Turbo HD DVR V4.1.10 Build180627 Release Notes (2018-06-27)

Firmware Basic Information	Firmware Version:	V4.1.10 build 180625
	SDK Version:	V5.0 build 180609
	player	4.8mini
	Play Library (PlayCtrl.dll)	7.3.5.0 build180209
	Web version	V4.0.1 build 180608
	Client version	V2.6.8.6build20180419

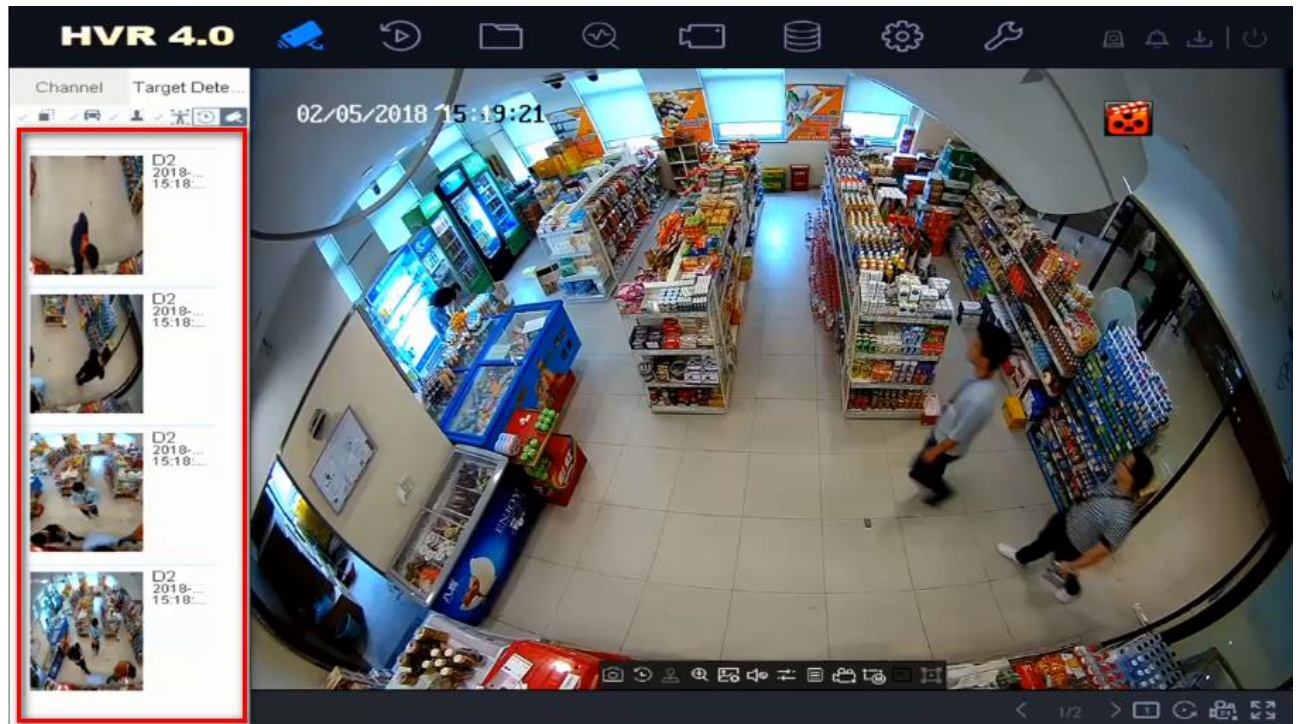
- Release new AcuSense DVR models: iDS-7200HQHI-K/S series, iDS-7200HUHI-K/S series;

- For iDS-7204HQHI-K1/2S, only 2 analog channels could configure false alarm filtering function for human & vehicle;
- For others, the number is 4.

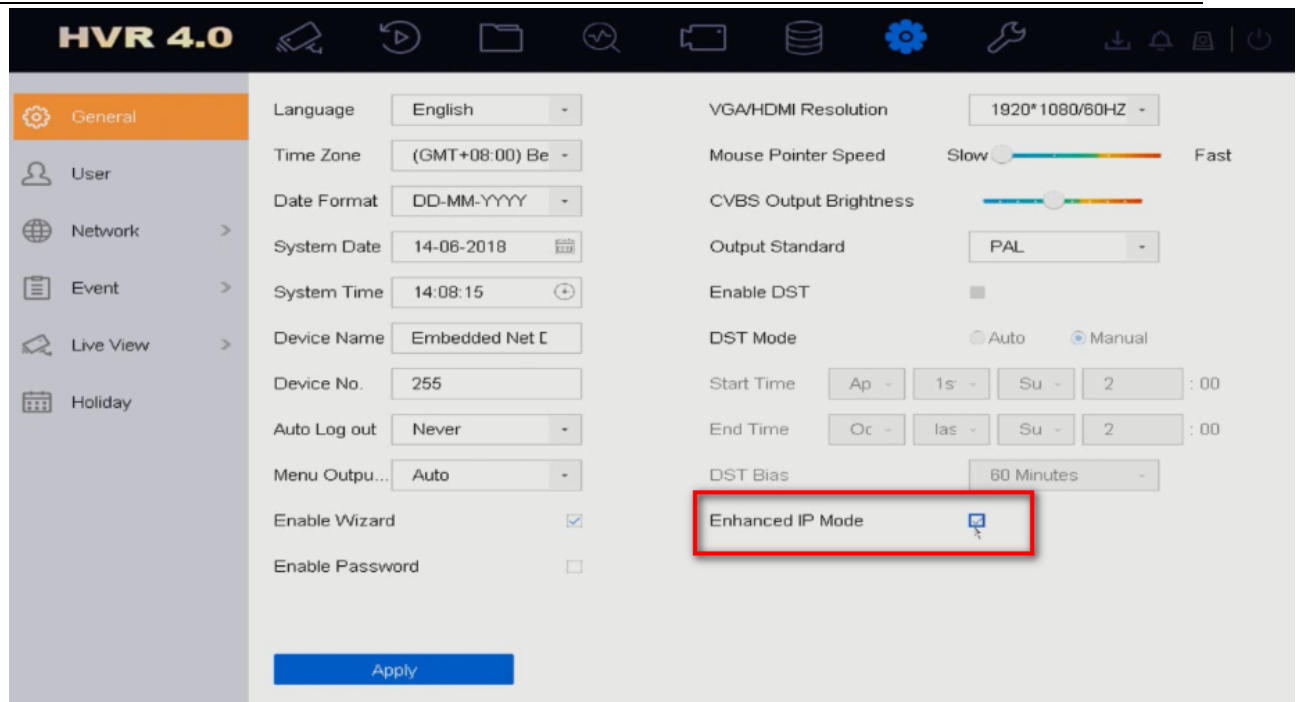
- ii. GUI 4.0 interface;
- iii. Dual stream recording is enabled as default and can't be changed;
- iv. IPC sub stream encoding parameters will be changed automatically after adding to DVR to resolution WD1/D1 (choose one from two) & bitrate 512K;
- v. Enhanced IP mode is supported and disabled as default.
While it is disabled, IPC can't be added unless analog channel is disabled; and smart events for analog channels are supported (line crossing, region intrusion, scene change, audio exception);
While it is enabled, smart events for analog channels are NOT supported, meanwhile more IPC can be added;
